Response to the Reviewers Comments

Manuscript number : egusphere-2023-2458 (NHES)

Article title: Detection of flooding by overflows of the drainage network: Application to the urban area of Dakar (Senegal)

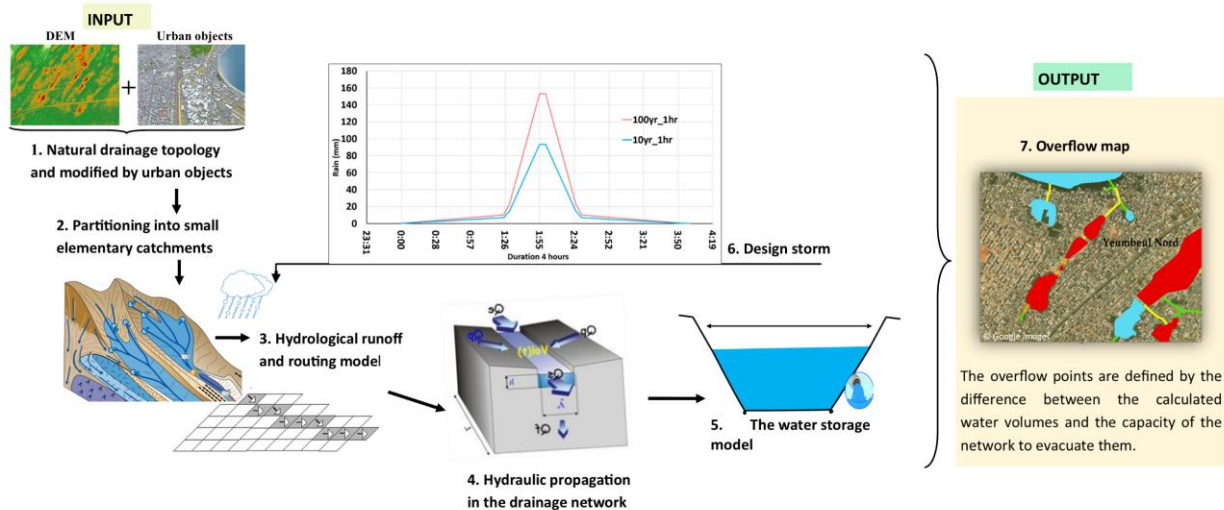
Comment 1. A flow chart of the methodology should be used to present the methodology. This will help the reader to understand the proposed modelling system

Response : We have inserted a flow chart of the methodology (see Figure 2).

Comparison of peak flow between an intense rainfall of 30 minutes and 1 hour with a total duration of 4 hours.

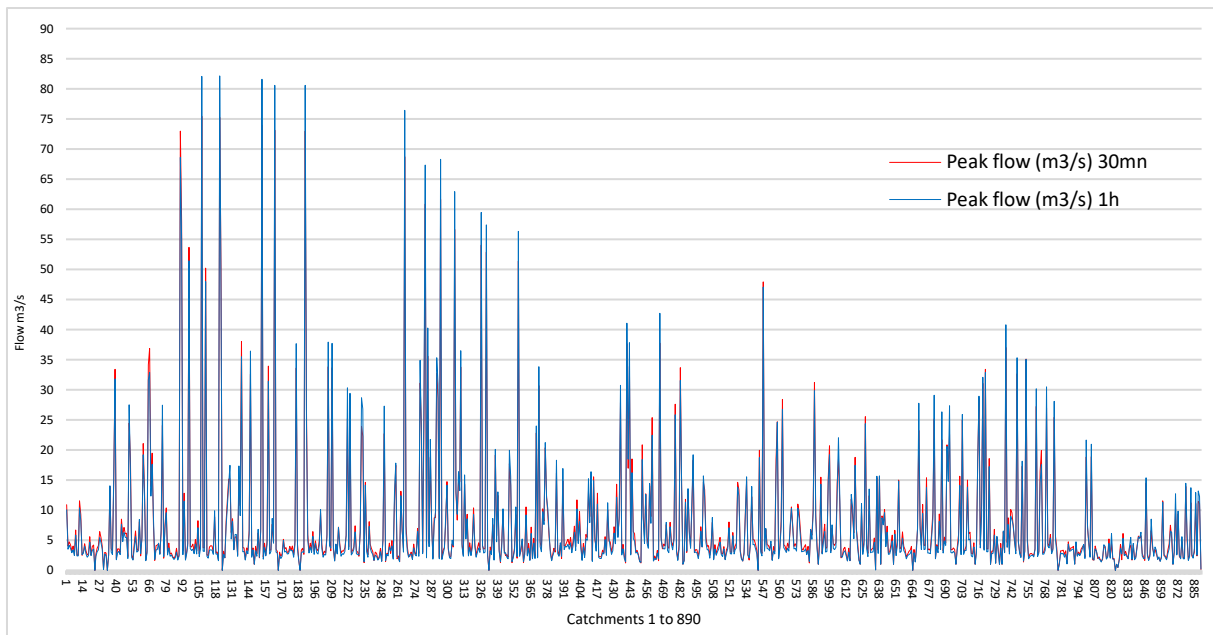
Comment 9. How and why a 4-hour rainfall is selected? Is 4 hours the critical duration of a storm? Please explain.

Response : Indeed 4 hours is mostly the life duration of rainstorms generally observed in African convective systems as analysed by Tadesse and Anagnostou (2010). We have applied this total duration for Dakar (see L458-463), even though detailed local analyses are required to assess the structure of significant precipitation events. The former critical duration of rain that we extracted from the IDF provided by Sane et al. (2018) is 1 hour. For future work, possible improvements would be to choose the critical duration less than 1 hour. Integrating durations less than 1 hour has been tested using the IDF curves recently updated by Diedhiou et al. (2024) . New simulations with the model show that the project rainfall associated with a critical duration of 1 hour tends to underestimate peak flows by an average of 7% compared with the project rainfall associated with a critical duration of 30 mn, regardless of the surface area of the watersheds, ranging from 10 ha to 12 km². Furthermore, a 10 mn led to underestimate the peak flows associated to a 30 mn critical period by an average of 9%.

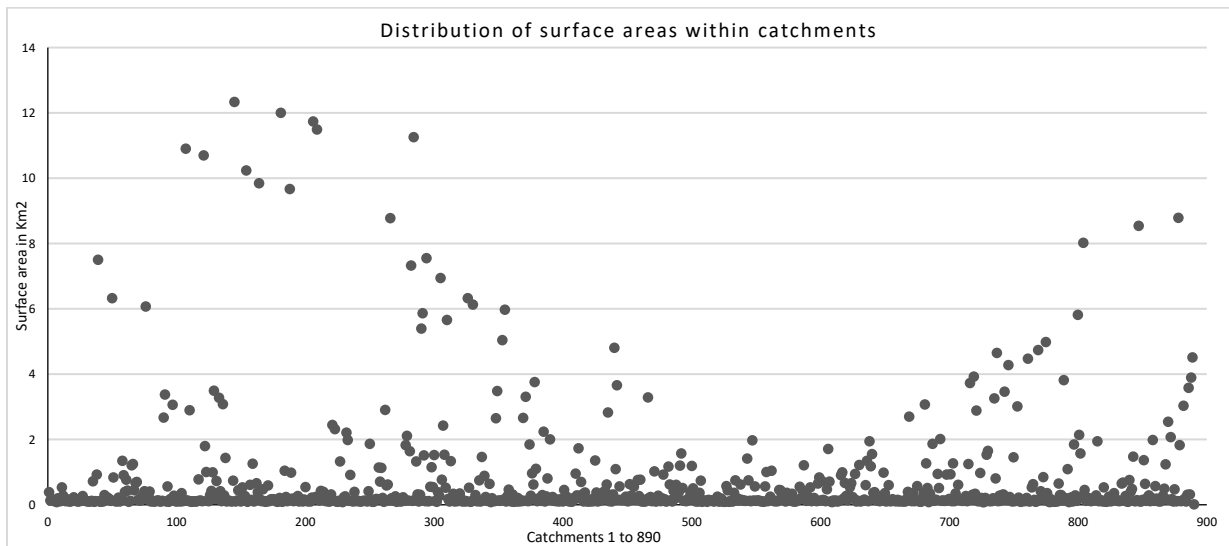
Comment 10. Why the spatial distribution of design rainfall is not considered? The same design hyetograph is applied over the study area.

Response : The simulations were carried out on the assumption that the rainfall was uniform over all the defined catchment areas. Such hypothesis does not account for areal reduction factor, but can be adopted because most of the catchments (i.e. 94%) have small areas, less than 2 km². The largest catchment areas account for 4%(2 to 6km²) and 2% (6 to 12km²) out of the 890 catchment outlets which have been considered, as shown below. We have inserted it into the discussion (L514-524)
